Project	IEEE 802.16 Broadband Wireless Access Working Group < <a href="http://ieee802.org/16">http://ieee802.org/16</a> >	
Title	DIUC/UIUC provision for supporting multiple advanced FEC types	
Date Submitted	2005-06-13	
Source(s)	Bin-Chul Ihm, Yongseok Jin, Kiseon Ryu, Changjae Lee and JinYoung Chun  LG Electronics, Inc.	Voice: 82-31-450-7187 Fax: 82-31-450-7912  <a href="mailto:bcihm@lge.com">bcihm@lge.com</a>
Re:	This is a response to a Call for Comments on IEEE P802.16e-D8	
Abstract	Provision of more DIUC rooms for supporting the multiple advanced FEC types. <b>Revised text is pink.</b>	
Purpose	This document is submitted for review by 802.16e Working Group members	
Notice	This document has been prepared to assist IEEE 802.16. It is offered as a basis for discussion and is not binding on the contributing individual(s) or organization(s). The material in this document is subject to change in form and content after further study. The contributor(s) reserve(s) the right to add, amend or withdraw material contained herein.

# DIUC/UIUC provision for supporting multiple advanced FEC types

Figure 2. Proposed scheme for providing enough MCS levels i.e., DIUC/UIUC's for each FEC type

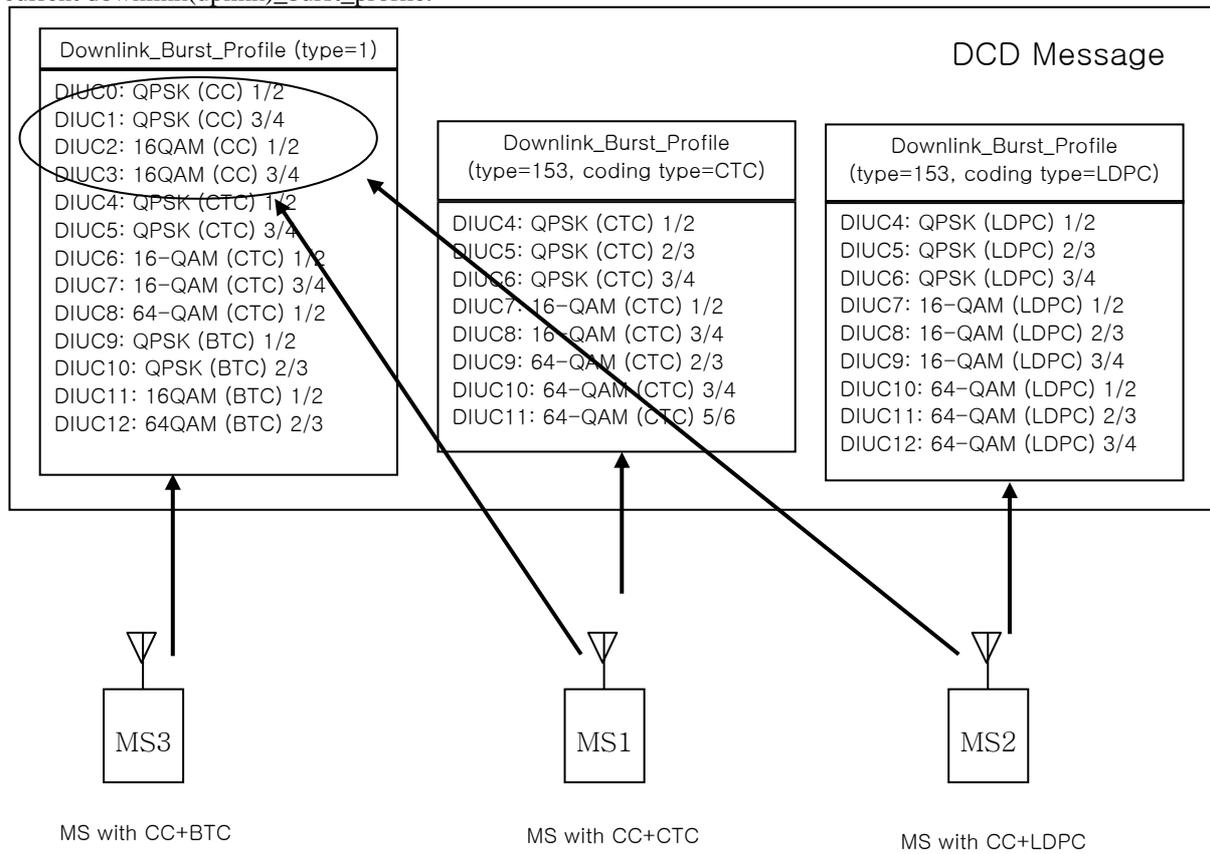
To provide more rooms for DIUC(UIUC) per each FEC type, we propose the extended DIUC(UIUC) which are dedicated to each FEC type as shown in Figure 2. 802.16-2004 version MS refers its DIUC(UIUC) set from downlink(uplink)\_burst\_profile and the later version MS can refer its DIUC(UIUC) set from each extended downlink(uplink)\_burst\_profile and downlink(uplink)\_burst\_profile for CC. In Figure 2, DIUC10 can be interpreted as one of three meanings of QPSK (BTC) 2/3, 64-QAM (CTC) 3/4 or 64-QAM (LDPC) 1/2 according to FEC type of MS. When there is no extended downlink(uplink)\_burst\_profile, the later version MS shall refer its DIUC(UIUC) set from

the current downlink(uplink)\_burst\_profile.

Figure 3. SBC\_RSP message to restrict MS to use just one optional FEC type

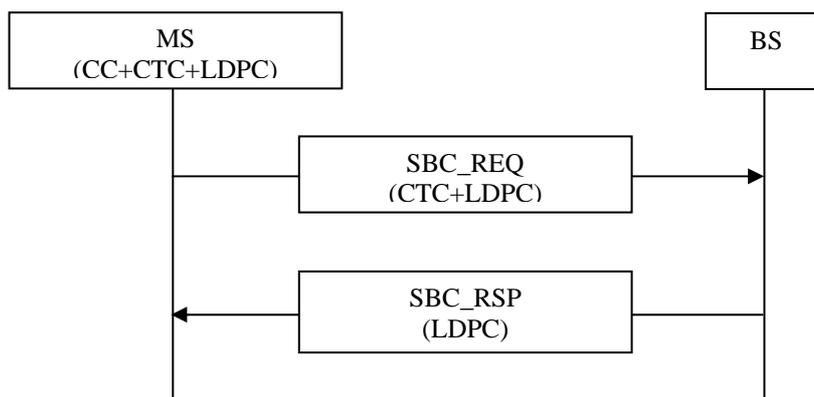
For example, when a MS was equipped two optional FEC such as CTC+LDPC, the proposed scheme results in confusion of DIUC(UIUC) definition. In this case, BS should restrict just one of two optional FEC types on the MS available after reception of SBC\_REQ indicating that MS has CTC+LDPC capability. This restriction can be delivered to the MS through SBC\_RSP message.

MS refers to DIUC/UIUC related to CC+ LDPC
